Form 3160-5
(June 2019)UNITED STATES
DEPARTMENT OF THE INTERIOR
BUREAU OF LAND MANAGEMENTFORM APPROVED
OMB No. 1004-0137
Expires: October 31, 2021**SUNDRY NOTICES AND REPORTS ON WELLS**
Do not use this form for proposals to drill or to re-enter an abandoned well. Use Form 3160-3 (APD) for such proposals.5. Lease Serial No. **NMNM15317**

8. Well Name and No. **RUTHLESS 11 FED COM/753H**9. API Well No. **30-025-51182**10. Field and Pool or Exploratory Area
WC-025 G-09 S253309P/UPPER WOLFCAMP11. Country or Parish, State
LEA/NM**12. CHECK THE APPROPRIATE BOX(ES) TO INDICATE NATURE OF NOTICE, REPORT OR OTHER DATA**

Ruthless 11 Fed Com 727H (FKA 753H) API #: 30-025-51182

EOG respectfully requests an amendment to our approved APD for
this well to reflect the following changes:

WELL LOCATION AND ACREAGE DEDICATION PLAT

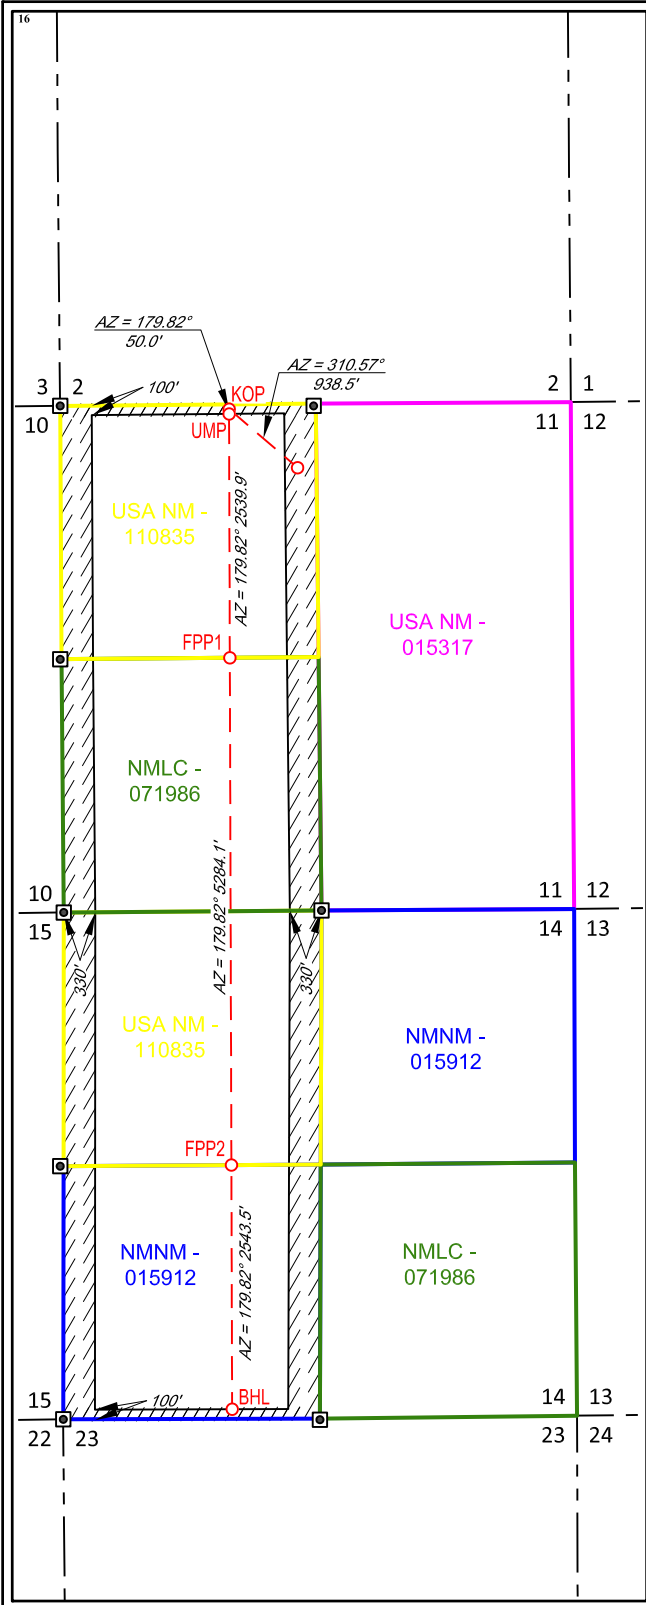
Change name from Ruthless 11 Fed Com 753H to Ruthless 11 Fed Com 727H.

Change BHL from T-25-S, R-32-E, Sec 14, 100' FSL, 2275' FEL, Lea Co., NM,
to T-25-S, R-32-E, Sec 14, 100' FSL, 1760' FWL, Lea Co., N.M.

¹¹ Bottom Hole Location If Different From Surface									
UL or lot no.	Section	Township	Range	Lot Idn	Feet from the	North/South line	Feet from the	East/West line	County
N	14	25-S	32-E	-	100'	SOUTH	1760'	WEST	LEA
